0002520USU/2413 USSN 10/643,979

REMARKS

Figure 2, Guide rod with multiple port ball end-cross section close up

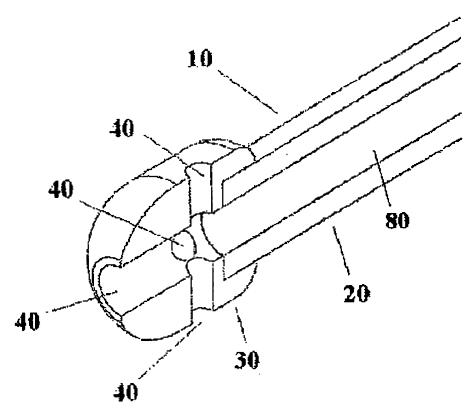
The Office Action further objects to the drawings asserting that at least one hole through the guide rod in communication with the channel is not shown. Figure 2 clearly shows a plurality of holes 40 in the guide rod enlarged end that are in communication with hollow cavity 80 of the guide rod:
